# FLYING HORSE NORTH FILING NO. 3 INITIAL/ INTERIM/ FINAL GRADING & EROSION CONTROL PLAN

EPC STORMWATER REVIEW COMMENTS  
IN ORANGE BOXES WITH BLACK TEXT

GRADING & EROSION CONTROL PLAN  
 COVER

Sheet identification: SHEET LE 2

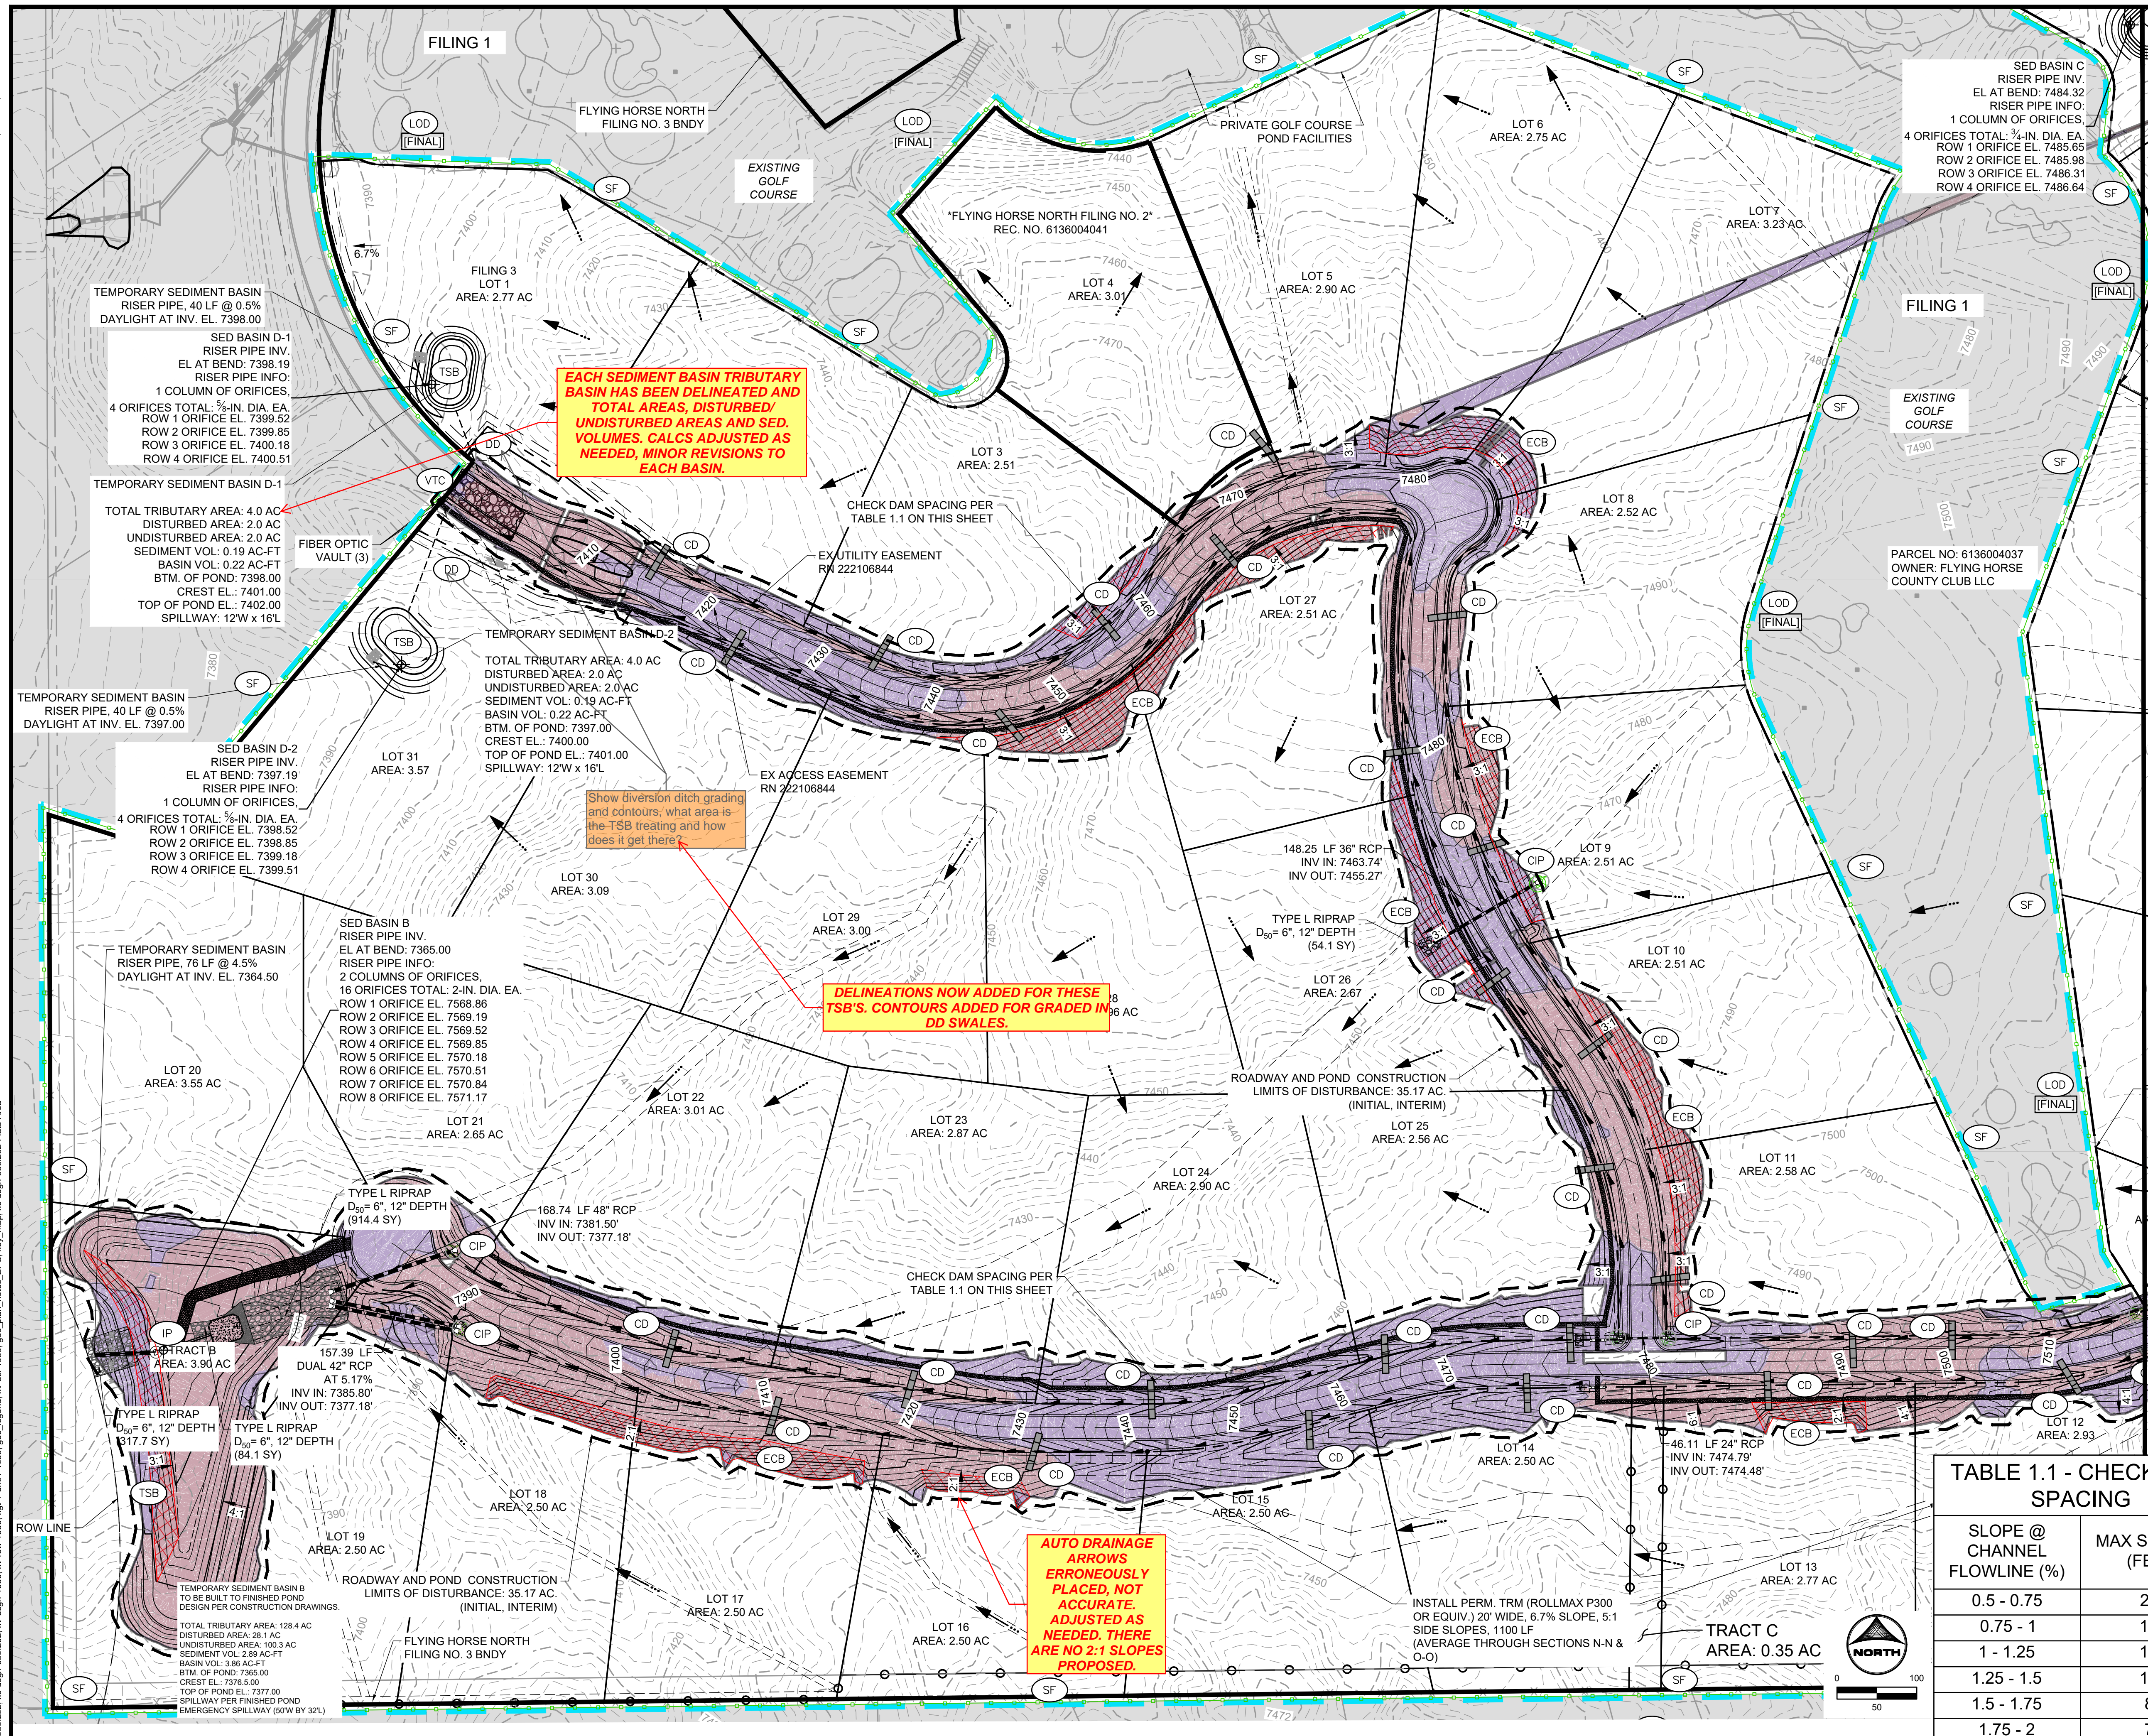
Add date of soils report

**SHEET  
 GEC  
 3**

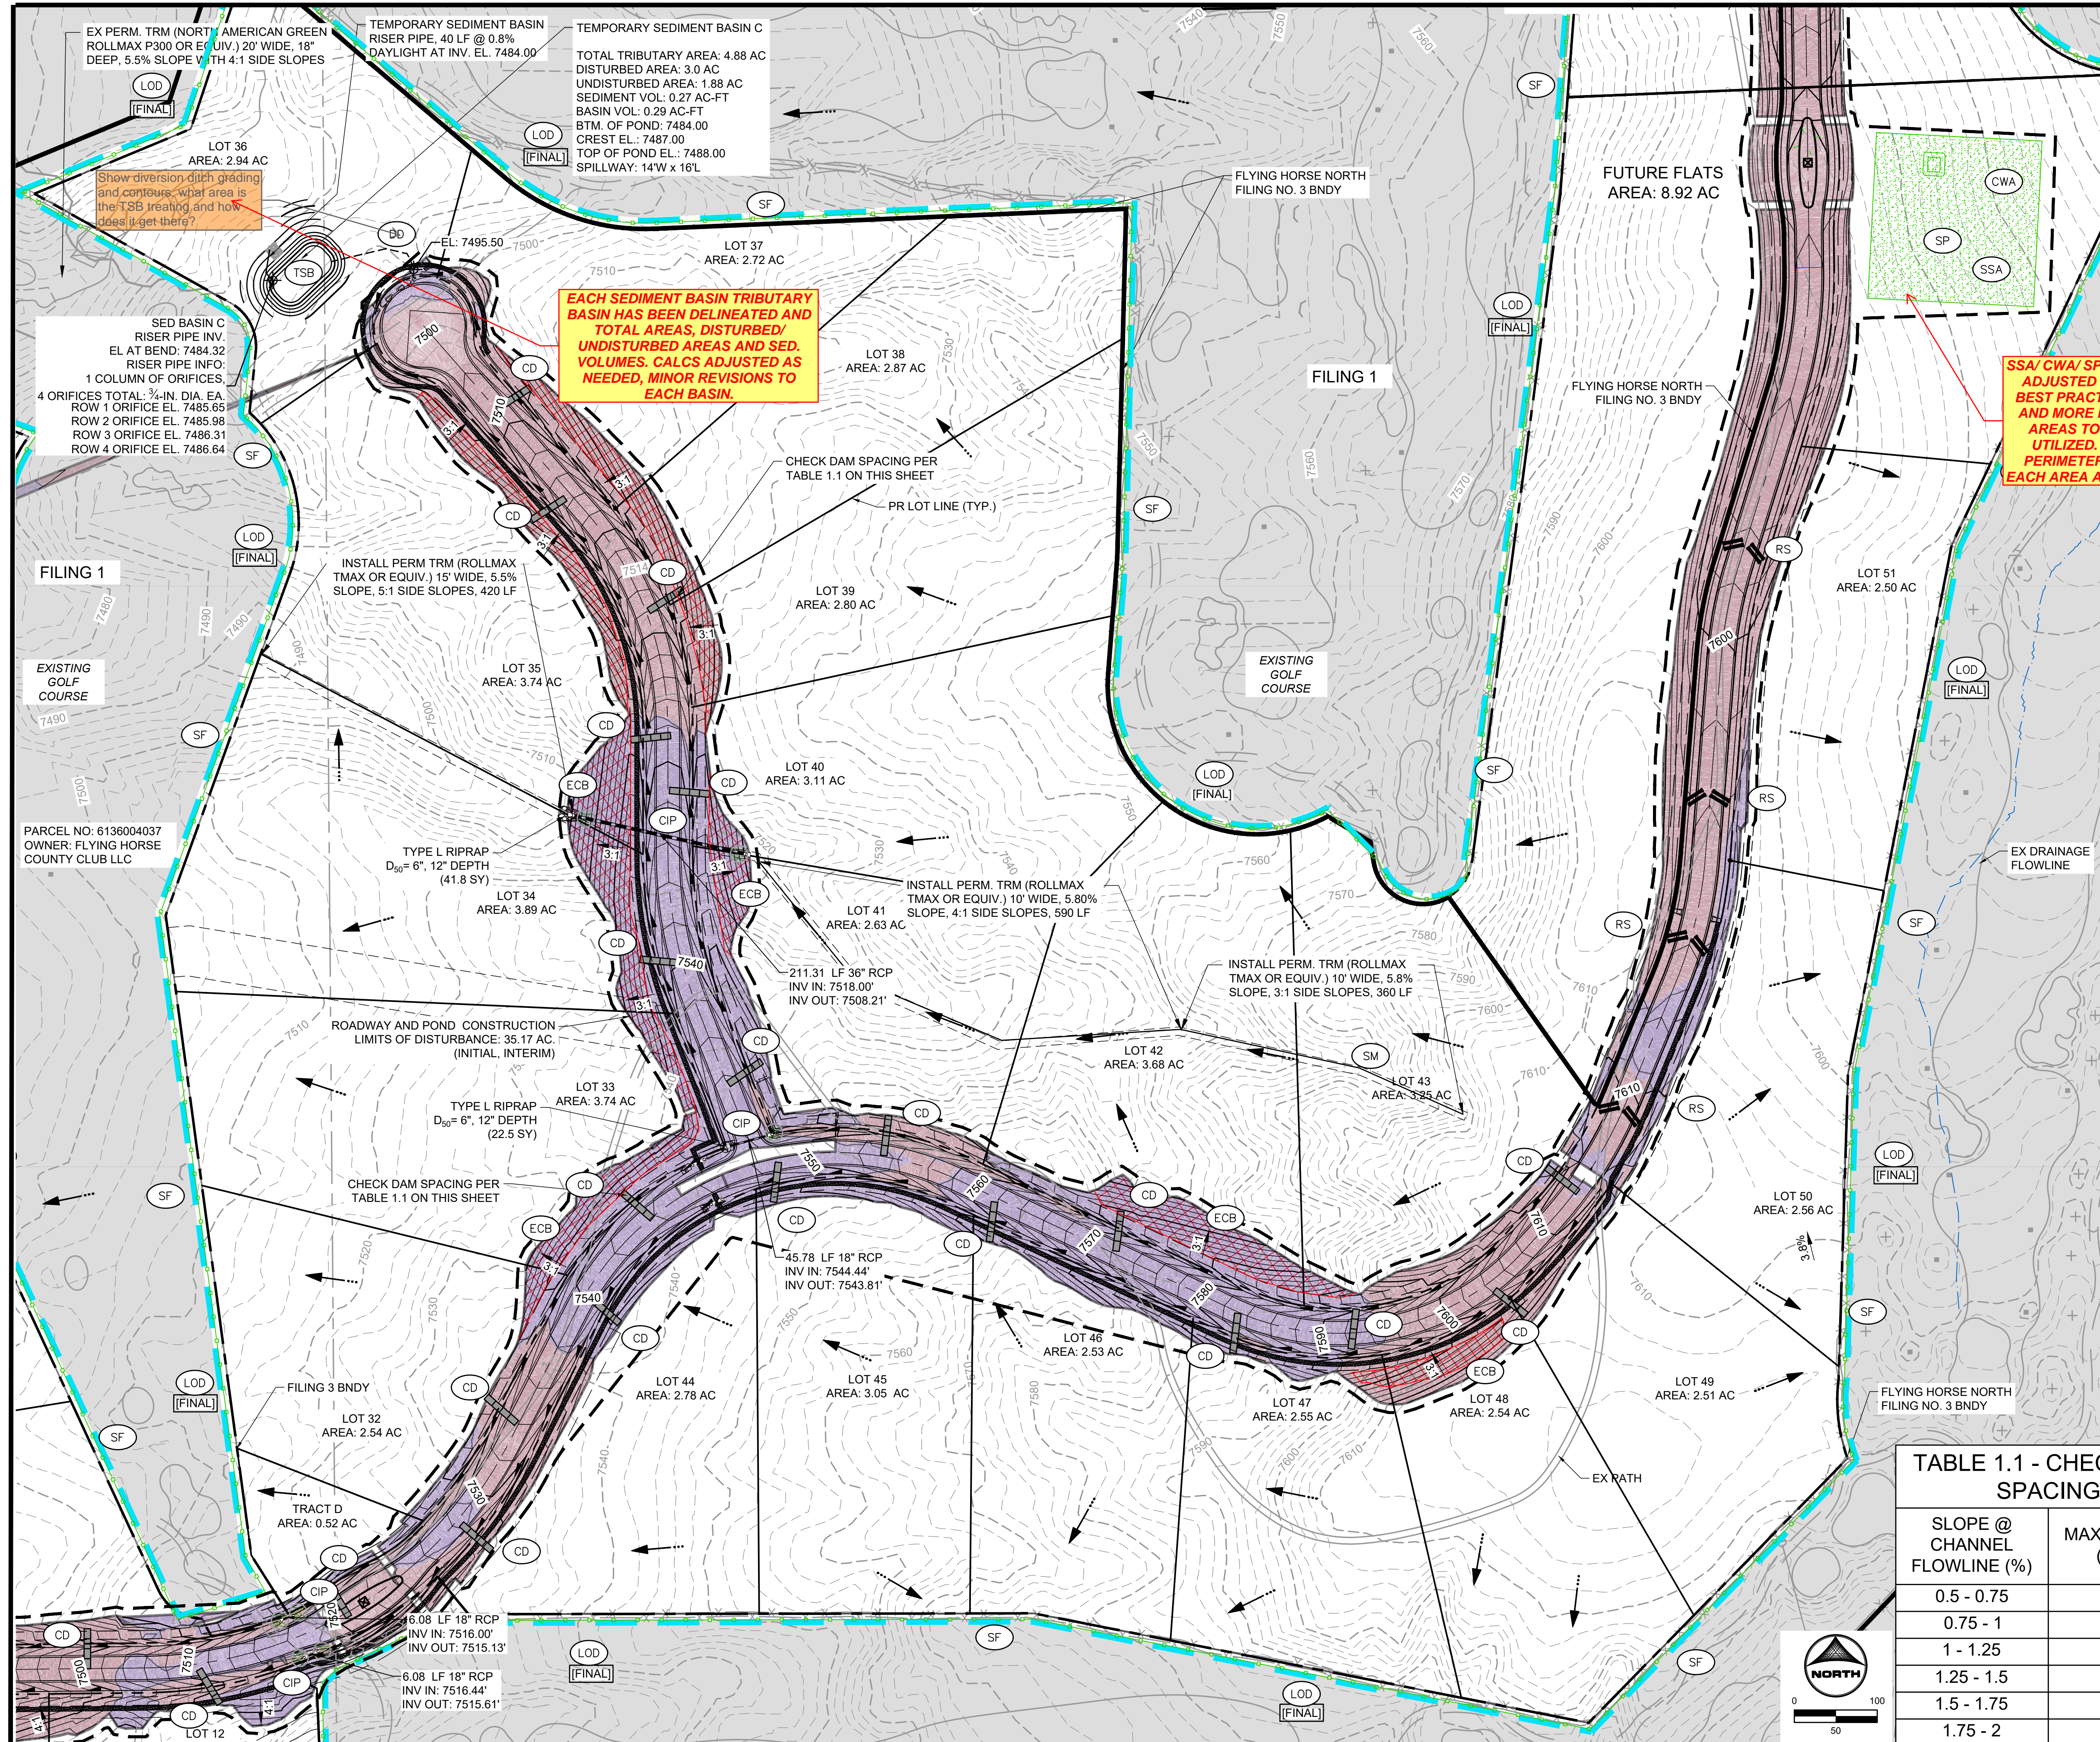
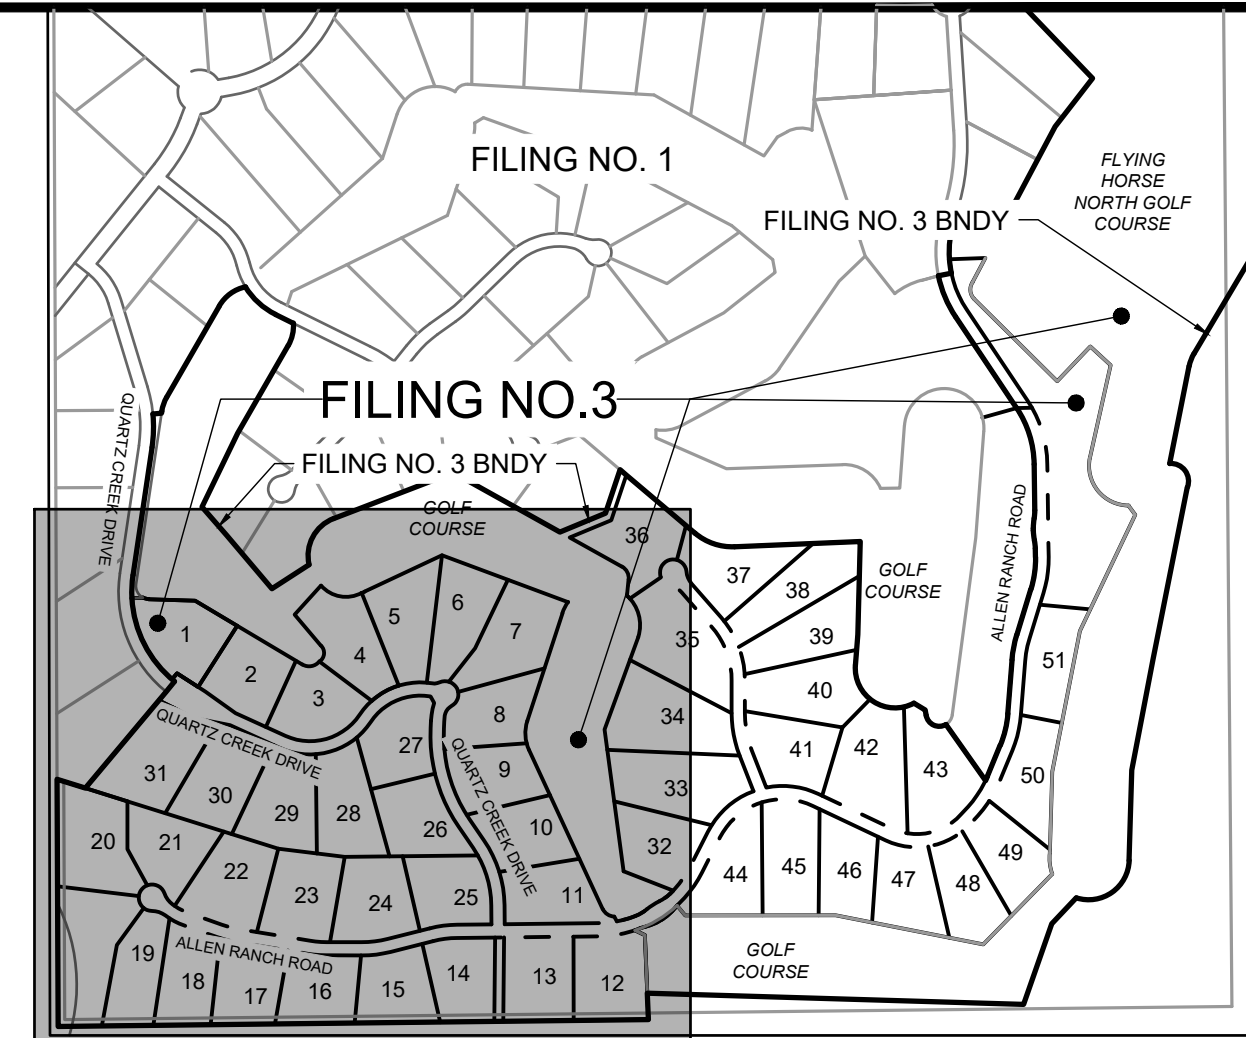
Show diversion ditch grading and contours, what area is the TSB treating and how does it get there?

Unresolved from Submittal 1 - FAE calls for Permanent Turf Reinforced Mat - show on legend as distinct hatching.

**DELINEATIONS NOW ADDED FOR THESE TSB'S. CONTOURS ADDED FOR GRADED IN DD SWALES.**

**AUTO DRAINAGE ARROWS ERRONEOUSLY PLACED, NOT ACCURATE. ADJUSTED AS NEEDED. THERE ARE NO 2:1 SLOPES PROPOSED.**
